ISO 16283-1:2014/FDAmD 1:2017(E)

Acoustics — Field measurement of sound insulation in buildings and of building elements — Part 1: Airborne sound insulation

AMENDMENT 1

Acoustics — Field measurement of sound insulation in buildings and of building elements — Part 1: Airborne sound insulation — AMENDMENT 1

a) Example 1

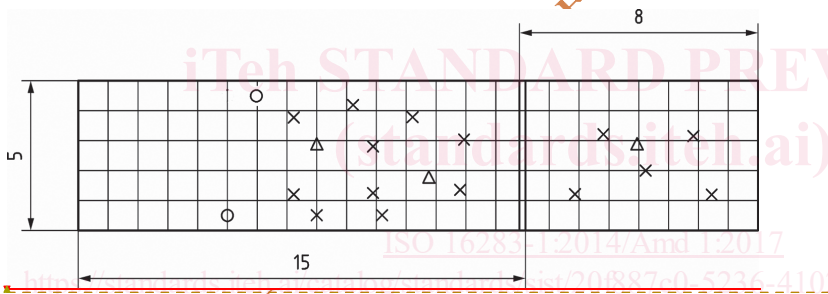
Replace Figure D.1 a) to i), k), m) and n) with the following figures:
